Enclosed are more detailed descriptions and sketches for the runoff controls for your feedlot pens. These suggestions are designed to provide solids settling that meets the minimum requirement of DNR regulations for lots under 1000 head capacity. The settling basins must slow the runoff to a velocity less than 5 feet per second for at least 5 minutes. Settled solids must be cleaned out of the basins as needed to keep the basins functioning properly. I have shown further treatment for the liquid that leaves the settling basin in the form of long travel through a grassed area or planned infiltration area. While this additional treatment is not specifically required by the rules, it does provide additional protection for waters downhill below the lot and further reduces the risk of negative water quality impacts.

From: Shouse, Shawn C [EXTAG] [sshouse@iastate.edu]
Sent: Thursday, August 27, 2009 9:14 AM
To: Olson, Dan P [DNR]; Shouse, Shawn C [CO SW]
Cc: Stipe, Dan [DNR]
Subject: RE: Dan Muhlbauer letter

Alison Manz, Dan Stipe, and I met with Dan, Dave, & Patti Muhlbauer, Even Vermeer, and Shawn Shouse this morning to discuss their plans for improved controls. A copy of Shawn's lett

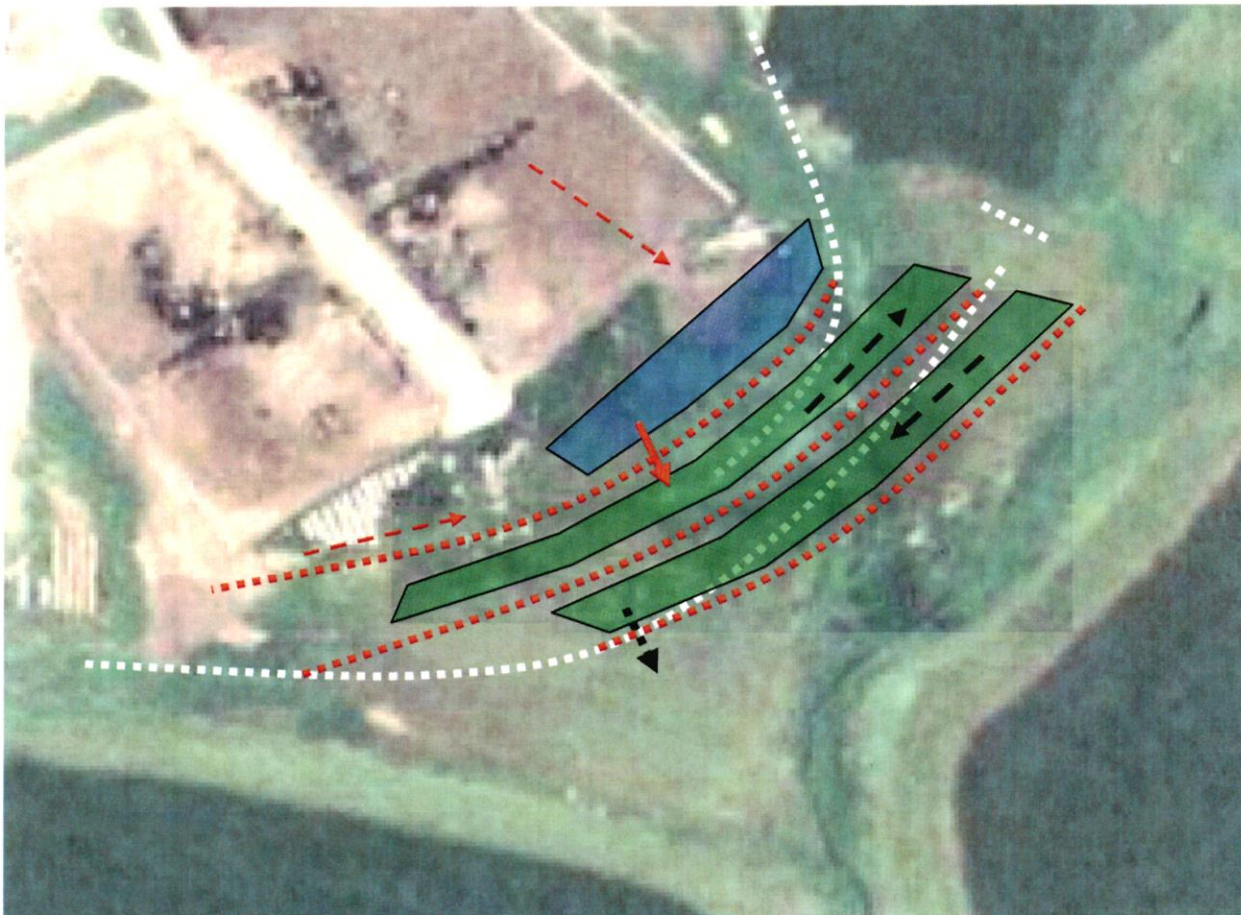
Below is a sketch of the home site feedlot settling basin as currently formed. Feedlot runoff flow direction is shown in red dashed arrows. Existing settling pool is shown in blue. Existing terraces are shown in white dashes. Settled effluent movement is shown in black dashed arrows. Elevations below reference point (ground at SE corner post) are noted.

As you note from the settling pool and the elevations, the upper terrace does collect runoff from the east pens, but it has a slight grade to the southwest and does not hold the runoff for settling. Currently it is acting as a diversion rather than a settling basin.

The lower terrace is graded with a low spot in the middle, approximately 3 feet lower than the east end. It is currently acting as a settling basin without a dewatering outlet. It will do a good job of settling solids, but will not drain and empty of liquid following runoff events.

What I would propose is that we re-grade the terraces so that the top terrace forms a settling basin and the lower terrace creates a filter/infiltration area that drains to the east and then back to the west below the terrace.

At the same time, I would suggest that we extend the upper terrace to collect runoff from the west pens as well. Solids could still be stored below the top terrace, but runoff water would be diverted into the settling basin.

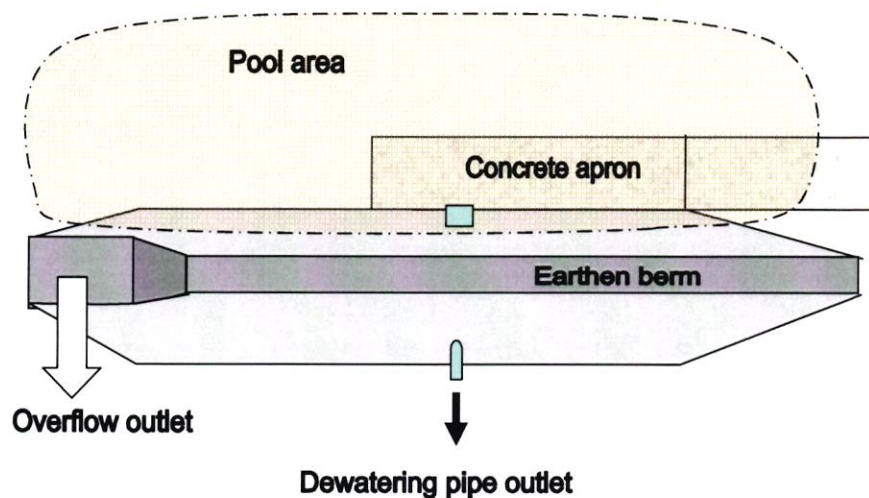
The sketch below shows the approximate existing terrace locations in white and the approximate modified locations in red, settling basin pool in blue and treatment areas in green.

This modification will create a settling basin pool roughly 250 feet long by 50 feet wide (12,500 square feet) to satisfy the recommended 1/35 of the drainage area (11,500 square feet).

The filter/treatment areas are about 40 feet wide and 350 to 400 feet long for a total of about 0.7 acres, or about 1/13 of the drainage area. These filter/treatment areas would be built to hold water 3-6 inches deep to allow longer infiltration times

Settling basin cross-section

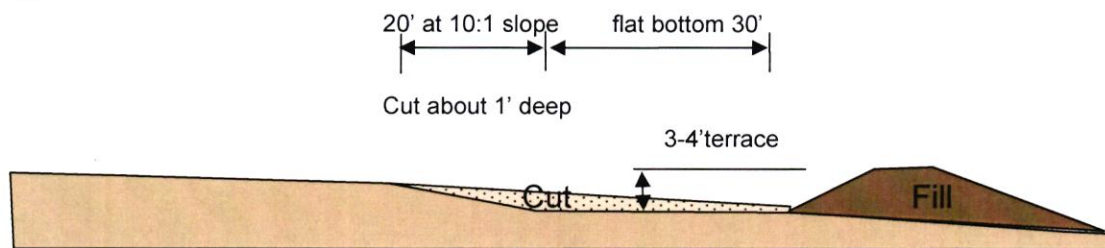
The pool area would be formed by cutting a flat bottom about 30 feet wide into the hillside above the terrace. Upslope from this flat bottom, the cut can be sloped upward at a 10:1 slope for another 20-30 feet where it will meet the existing soil grade.

The basin bottom could slope very slightly toward the outlet box, but not more than about 6 inches of slope from one end to the outlet.

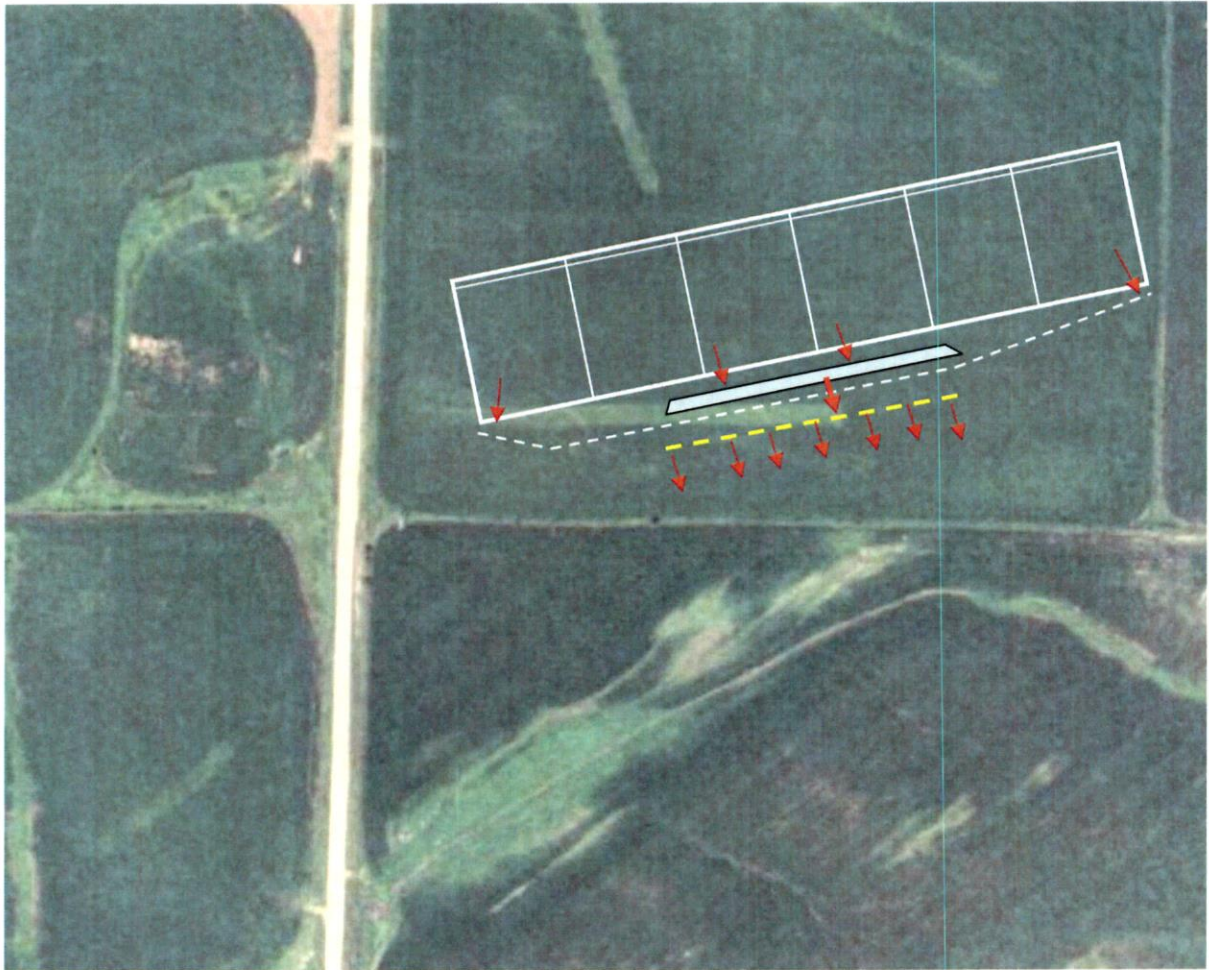
Below is a sketch of the feedlot site at David's.

The total runoff area for the pens is about 310,000 square feet. Using a pool area of 1/35th of the drainage area, $310,000/35$ equals approximately 8,900 square feet of pool surface when the basin is full to the overflow level. Your existing upper basin measures about 180 feet long by 60 feet maximum width when the liquid is to its maximum level. This corresponds to an estimated surface area of 8600 square

feet. Currently, the lowest spot around the upper basin is at the west end of the berm. But the middle of the berm is within a couple inches of this elevation. The berm is at significant risk of damage from overflow at the middle of the berm. I would recommend adding some additional fill to the middle of the berm so that the entire berm is at least one foot higher than the overflow area around the west end of the berm. With this modification and a little more cleaning of accumulated solids on the uphill side of the basin, I think you will achieve the required basin area to meet the rule requirement for solids settling in the upper basin.

The primary settling basin requires a dewatering outlet. I would suggest a non-perforated riser pipe or box type outlet with an operable weep hole at the bottom. Using this type of outlet, we can selectively hold or release the storage volume from the settling basin to the lower basin and treatment area. As with the home site, I would be happy to help you design the outlet for manual control. I would recommend a 6" outlet pipe from the basin. As was mentioned in my previous letter, either the Agri-Drain pond box outlet or a home-made outlet box or riser pipe would be satisfactory. The top of the riser box or pipe or stoplogs would be set about 6 inches below the elevation of the overflow spillway around the west end of the basin berm.

Settling basin cross-section

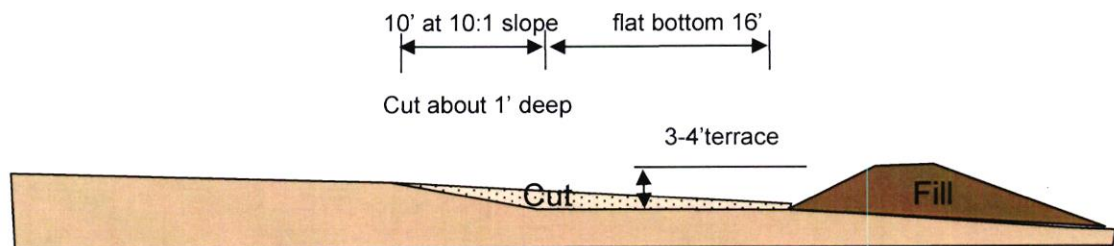
These cross-section dimensions will actually give a larger basin pool surface area than minimum requirement calculated above because the pool will back up onto the ground surface above the cut area. Storage volume will also be larger than calculated above. I don't think you want the bottom much less than 16 feet wide to allow cleaning when dry with a box scraper and tractor. The cut and fill pattern for the basin berm can be consistent along the length if you let the berm curve and follow the land contour. Alternatively, you can make the berm straight, and the cut depth will be greater over the ridge areas than in the valleys. I think either method is acceptable as the existing land elevation is consistent to within two feet in the area we plan for the basin.

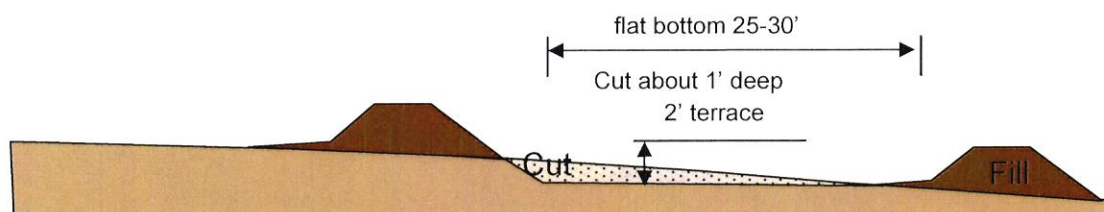
Based on aerial photos and topographic maps, and on your suggestion following visual assessment of the field, I am going to suggest establishing a treatment/infiltration area in the southeast corner of the field along the road. This should allow us to utilize suitable soils and favorable land slopes and should also allow easy observation of the treatment area condition and operation.

Prior to construction, I would return to do more detailed measurement on the site to determine actual locations and shapes of the individual treatment area cells. The sketches in this letter are based on assumptions I'm making from contour lines on the topographic map.
